PIC16C621A Rev. A Silicon Errata Sheet

The PIC16C621A (Rev. A) parts you have received conform functionally to the Device Data Sheet (DS30235G), except for the anomalies described below.

FIGURE 1: $\overline{\text{MCLR}}$ EXTERNAL CIRCUIT

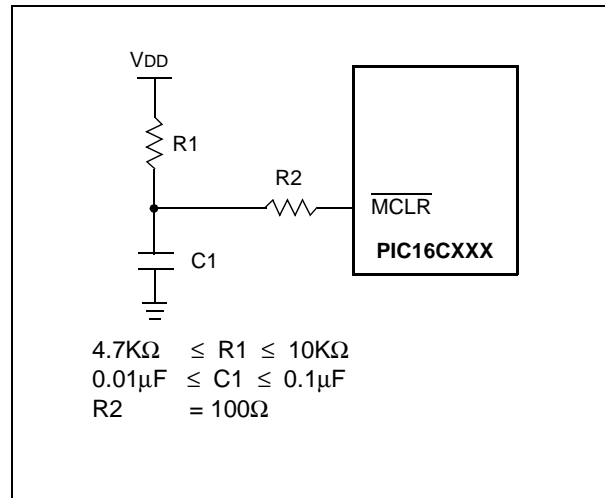
1. Module: RESET

The minimum specification for the $\overline{\text{MCLR}}$ must be met in order to RESET the PIC16CXXX. If a $\overline{\text{MCLR}}$ pulse occurs that is less than the minimum specification (parameter #30), improper device operation can occur.

If the Minimum specification cannot be met, then an external circuit must be used to insure that any pulse width less than the specification will be filtered before it reaches the $\overline{\text{MCLR}}$ pin.

Work Around

A possible circuit is shown in Figure 1. Proper design validation needs to be done to ensure desired operation over the applications operating conditions

Figure 1: Wake-up from Sleep

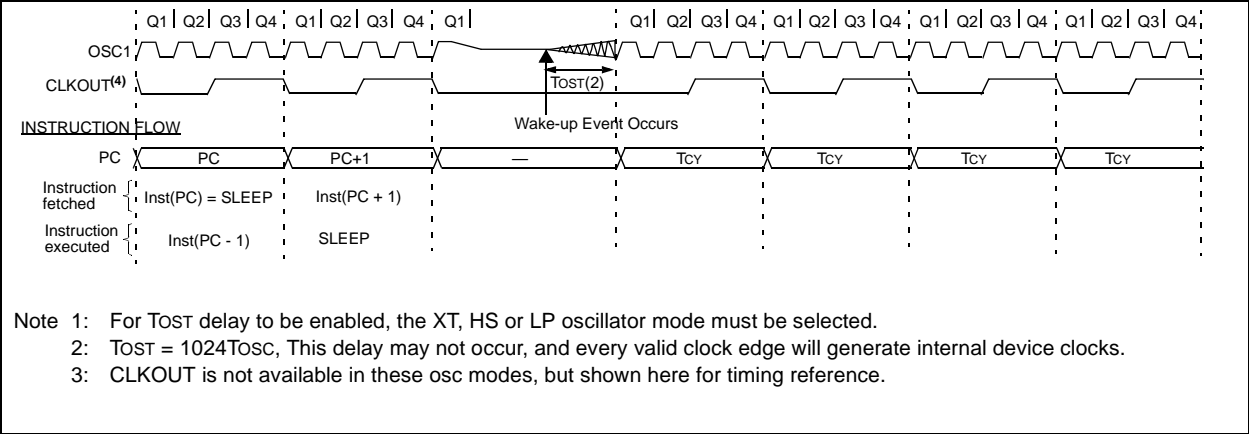
2. Module: OSCILLATOR

The Oscillator Start-up Timer (TOST) delay may not occur when the device wakes-up from sleep.

Figure 1 shows the start-up of the crystal after the event that causes the device to wake up from sleep mode (as specified in device data sheet). The start-up time (TOST) may not occur.

The events that wake-up the device from sleep are:

- An interrupt
- A WDT overflow (wake-up)
- A Brown-out Reset
- A $\overline{\text{MCLR}}$ reset

In applications where time based measurements are started immediately after wake-up from sleep, the suggested work around should be implemented.

Work Around

After the SLEEP instruction, do a software delay of 256 TcY (same as 1024 TOSC). At the Reset and Interrupt vector addresses, test to see if the device woke from sleep (the $\overline{\text{TO}}$ and $\overline{\text{PD}}$ bits), and if the device did wake from sleep, ensure that the total cycle delay is 256 TcY.
